JSP25-02 CAMELOT PARC TOWNHOMES

**PLANNED SUBURBAN LOW-RISE (PSLR)
OVERLAY DEVELOPMENT AGREEMENT –
CAMELOT PARC TOWNHOMES**

A PLANNED SUBURBAN LOW-RISE (PSLR) OVERLAY RESIDENTIAL COMMUNITY CITY OF NOVI, OAKLAND COUNTY, MICHIGAN PSLR OVERLAY PRELIMINARY PLAN

AVOLON PARK DEVELOPMENT, LLC
CAMELOT PARC TOWNHOMES
PS/R OVERLAY CONCEPT PLAN
REMOVAL PLANS

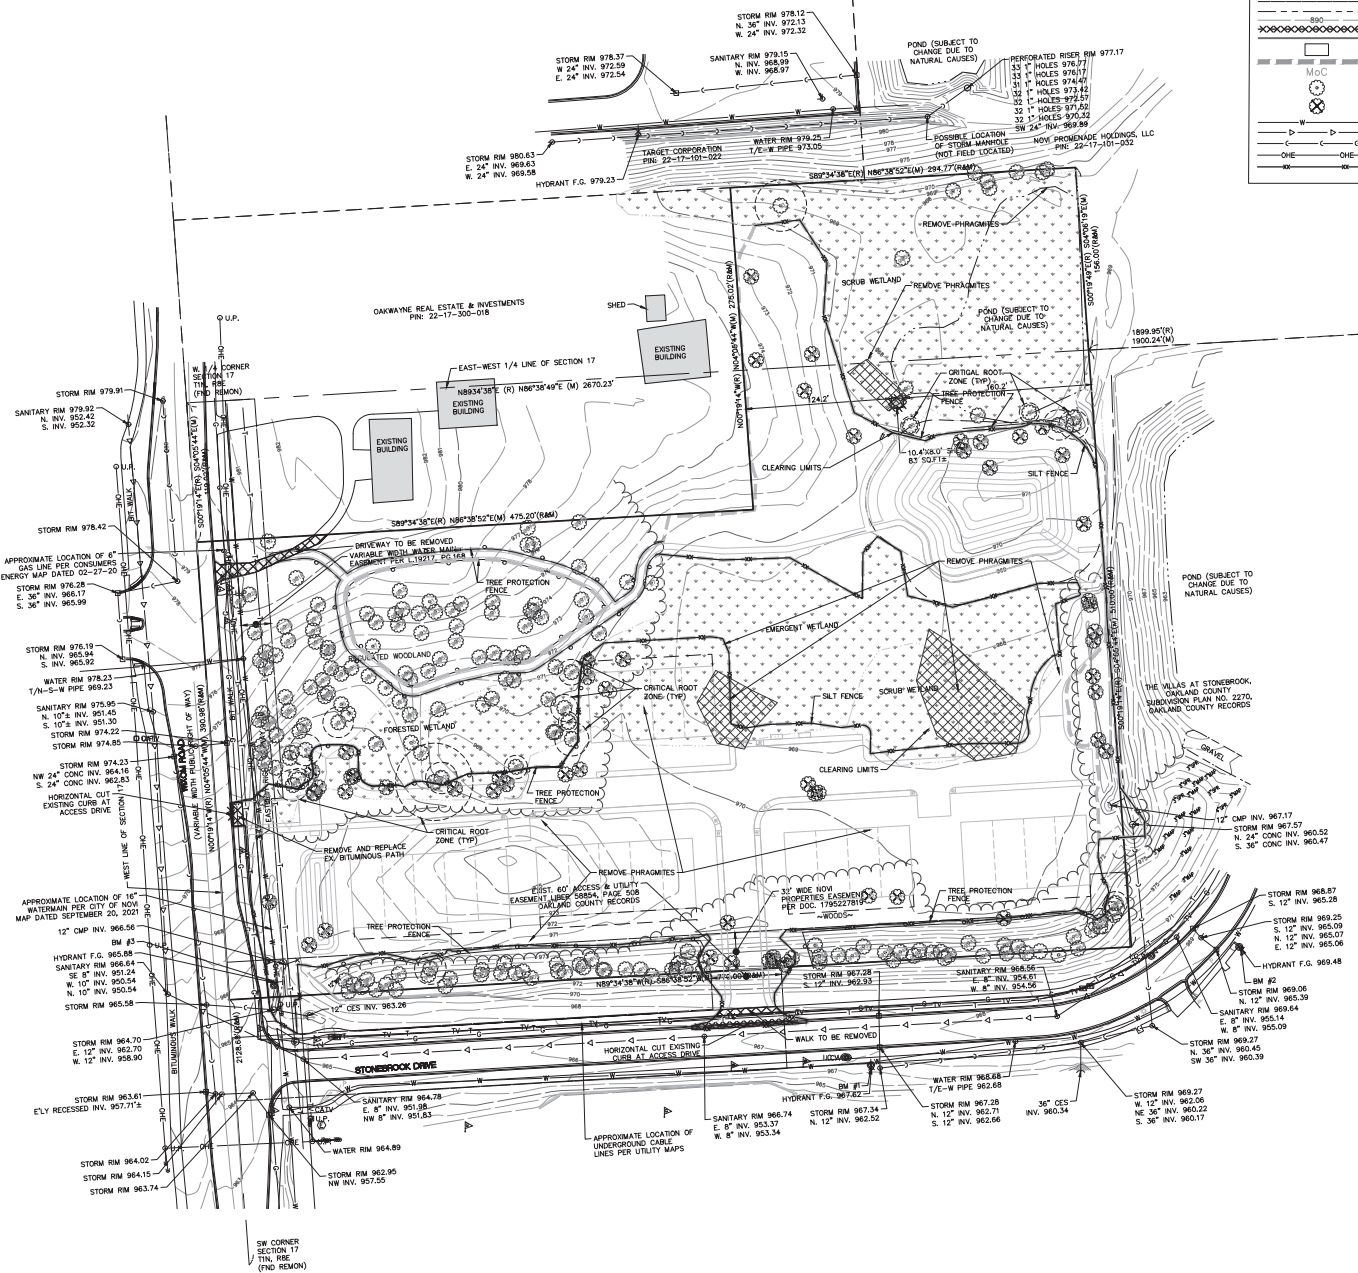
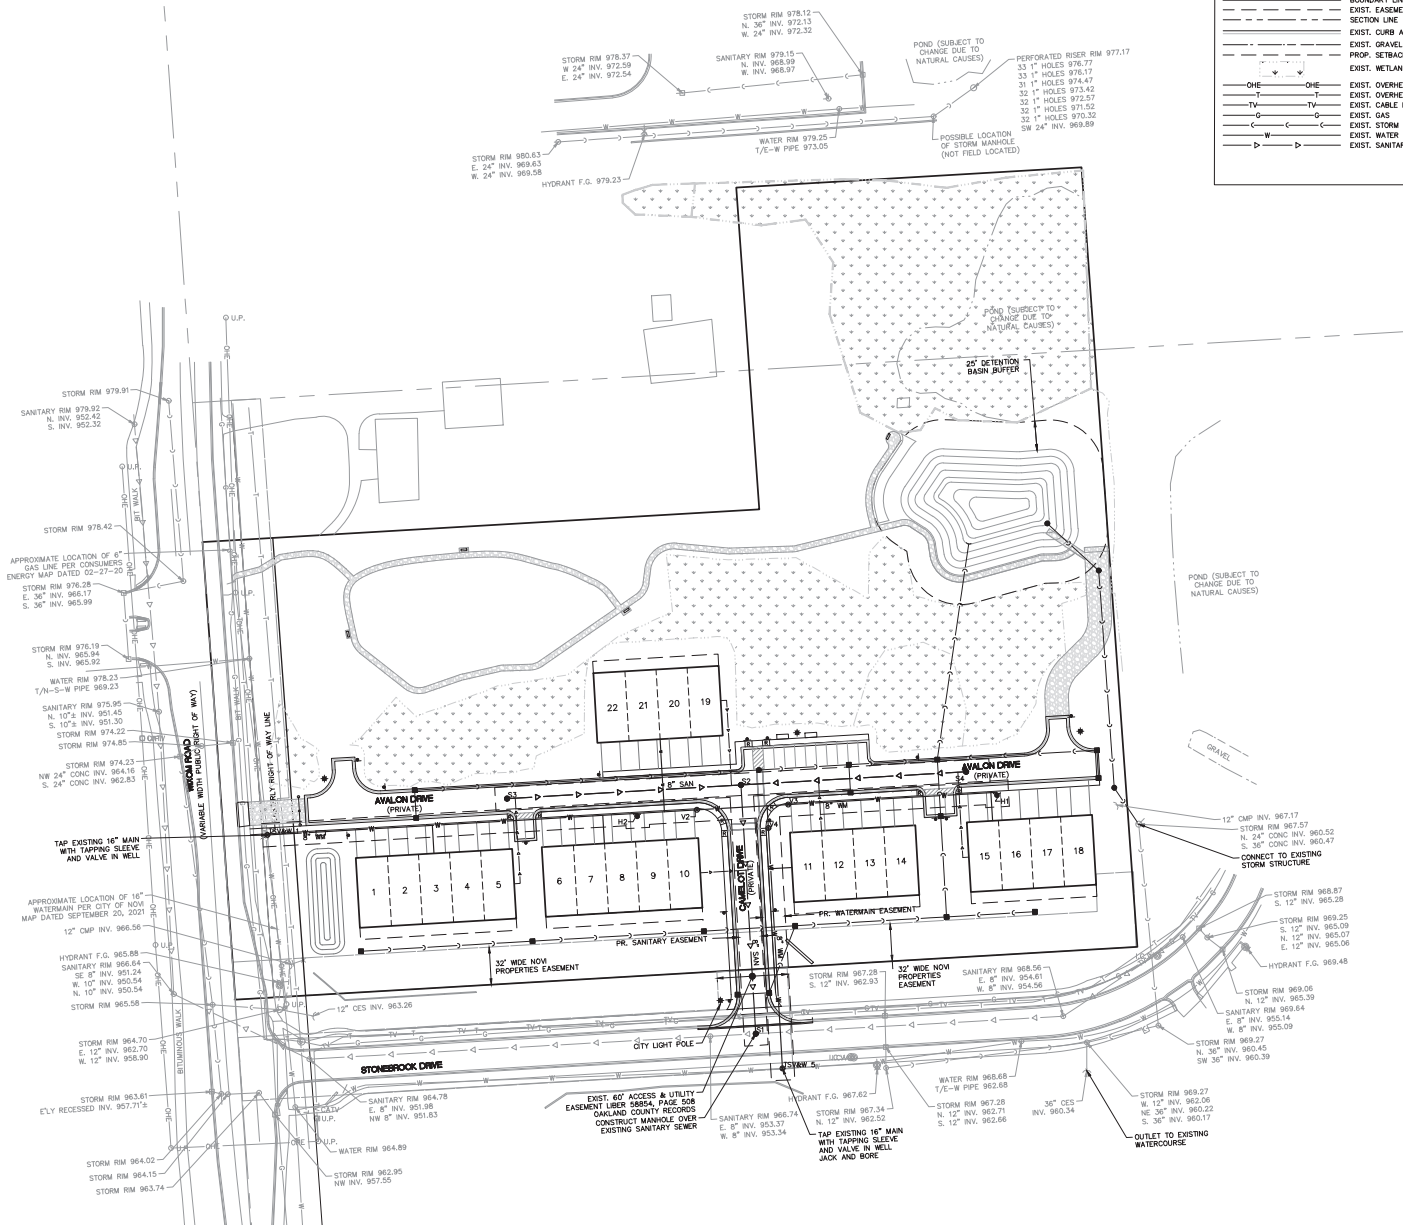
Phragmites and Japanese Knotweed Control (Zoning Sec 6.B)	All populations of Phragmites and/or Japanese Knotweed shall be eliminated from the site	- Phragmites populations are shown on Sheet 3 along with removal instructions. - No Japanese Knotweed was found.	Yes	
Landscape Notes and Details– Utilize City of Novi Standard Notes				
Plant List (LDM 4,11) – Include all cost estimates				
Quantities and sizes		No plant list is provided	Yes	<u>Please add a plant list no later than the Final Site Plan.</u>
Root type		No plant list is provided		<u>See above</u>
Botanical and common names	At least 50% of plant species used, not including seed mixes or woodland replacement trees,	No plant list is provided		<u>See above</u>

- The applicant has listed the number of replacements required on Sheet 10.
 - **Requested clarification:** Either a separate sheet or details should be added to Sheet 3 showing the final development plans in conjunction with trees that will remain on-site. Based on Davey Resource Group's January 10, 2023 review, trees such as Tree 9688 are within the regulated woodland. Based on the location of the woodland fence (see Comment 9), it is assumed the critical root zone of this and other trees will be impacted and should be reflected in the count of trees to be impacted even if they remain. Therefore, tree replacement calculations should be updated to reflect impacts to the critical root zone of regulated woodland trees.

L-1

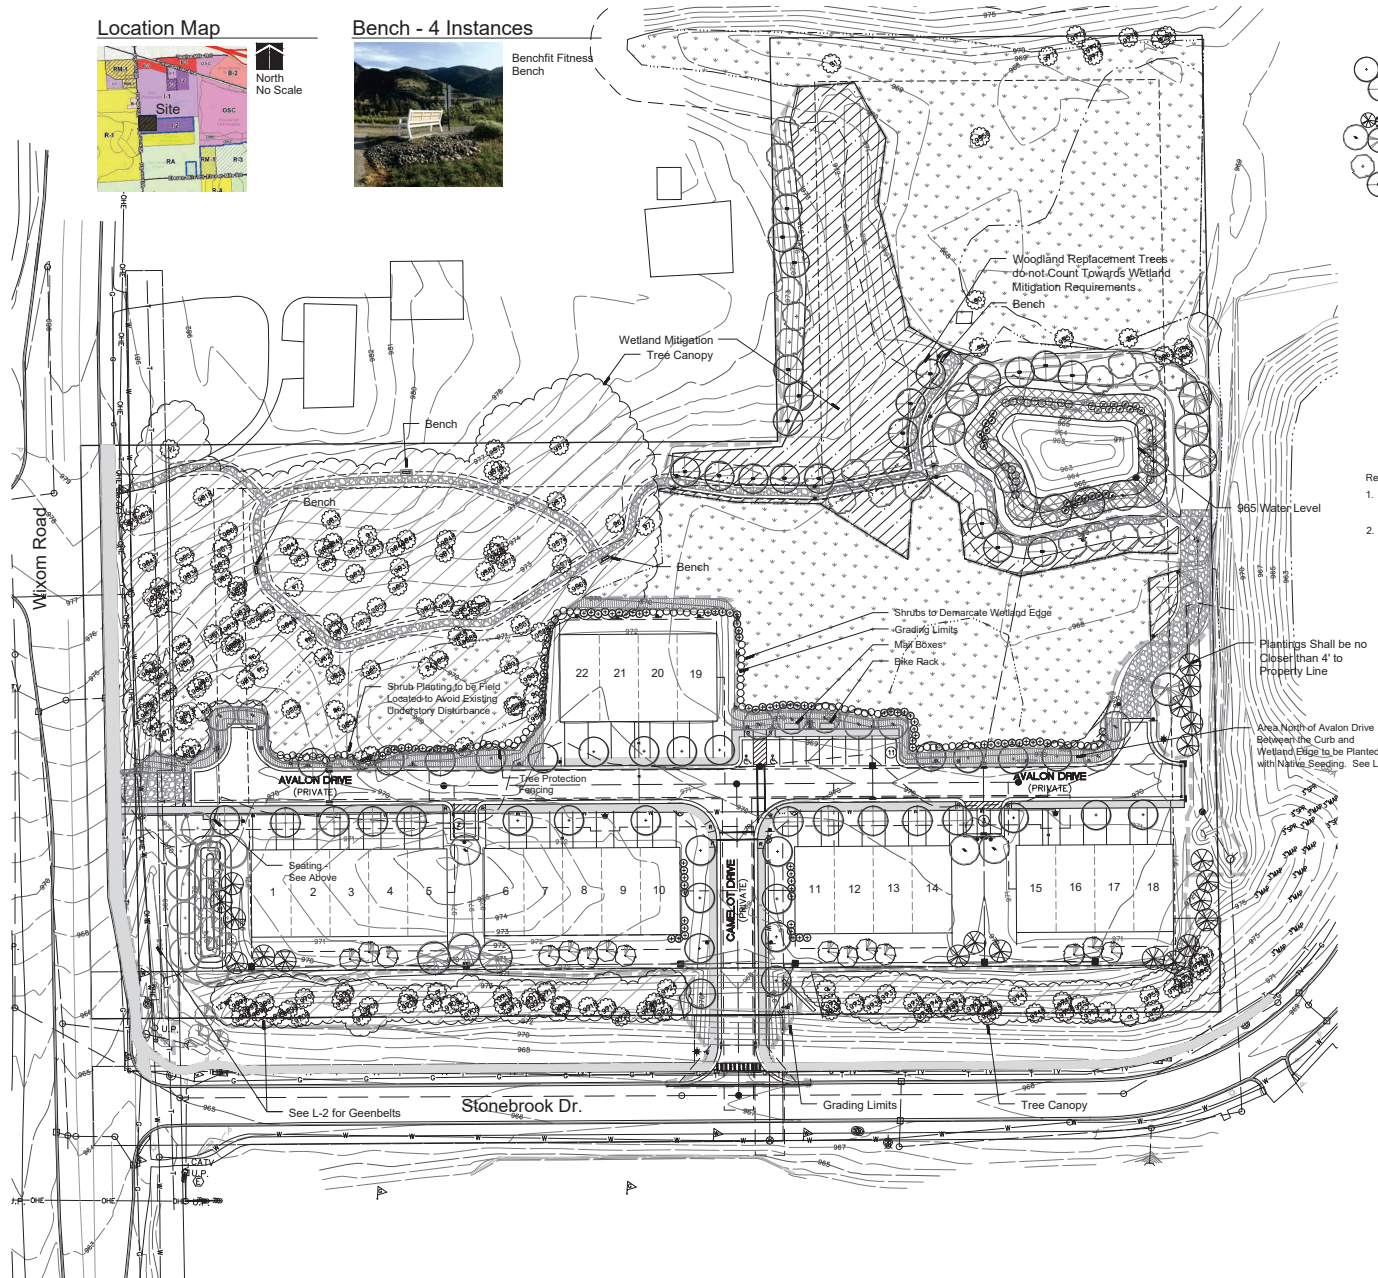
- The applicant has stated on Sheet L-1 that all trees will be replaced via a non-refundable payment into the City of Novi Tree Fund. The applicant should list on the site plan (where appropriate) that **all 43 replacement trees will be paid into the City of Novi Tree Fund via a non-refundable payment of \$17,200 (43 x \$400).**

- o **Requested Edit:** Sheet L-1 should be updated to reflect the number of replacements listed on Sheet 10. Note that not all removals of trees on-site are of regulated trees.

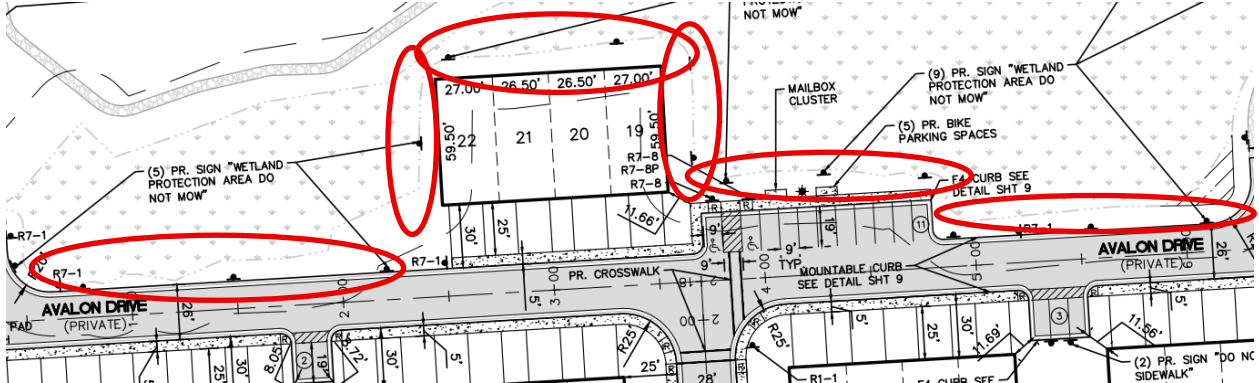
Requested edit: In future submittals, buffer impacts should be differentiated by permanent and temporary impacts (if applicable). If impacts are temporary, descriptions or sequencing should be provided showing how the temporary impacts will be restored. The temporary wetland restoration sequencing provided on Sheet 7 can be applied to any temporary buffer impacts – the header will need to be updated. Identify any temporary buffer impacts using a different symbology in the site plan.

The italicized text and image below are originally from Comment 5 in the July 2025 wetland review and has been addressed in the rrPSLR submittal on Page L-1.

Due to the extensive proposed loss of wetland buffer along the southern remaining wetland area, it is requested that the applicant perform environmental enhancement along the southern portion of the remaining wetland (see screenshot below). The applicant should plant at least three different species of wetland rated shrubs throughout the southern boundary of the wetland. This will allow a small separation from the wetland and the proposed development. Additionally, it will deter any accidental mowing of the wetlands and remaining buffer areas. Shrubs could include three of the following species:

Requested Placement locations

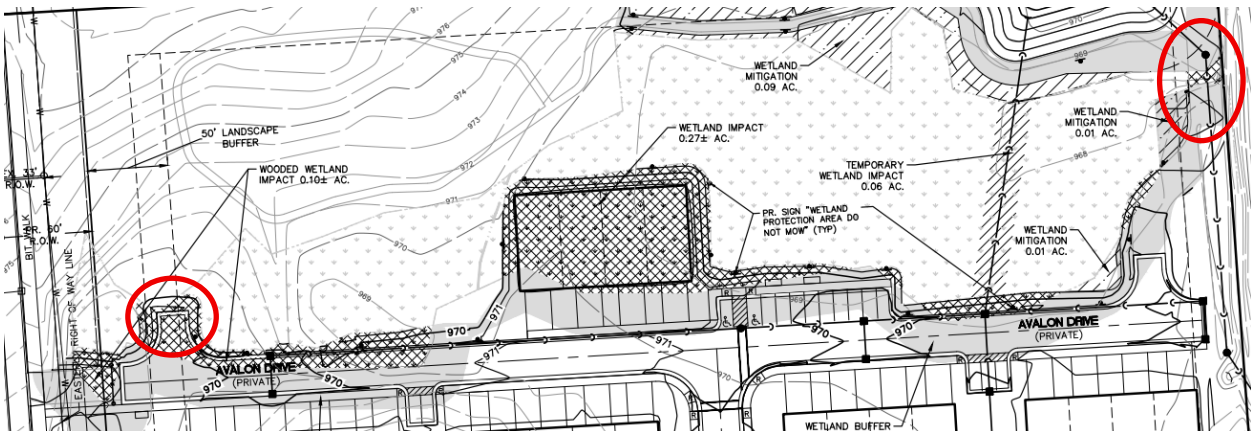
6. Portions of the wetland may become disconnected by the placement of fill throughout the site. It is requested that wetland equalizer culverts or similar structures be placed beneath roads that allow the wetlands on-site to remain connected. Specifically in the locations circled below. The eastern circled area reflects the approximate off-site portions of the wetland as delineated by ASTI on April 30, 2025.
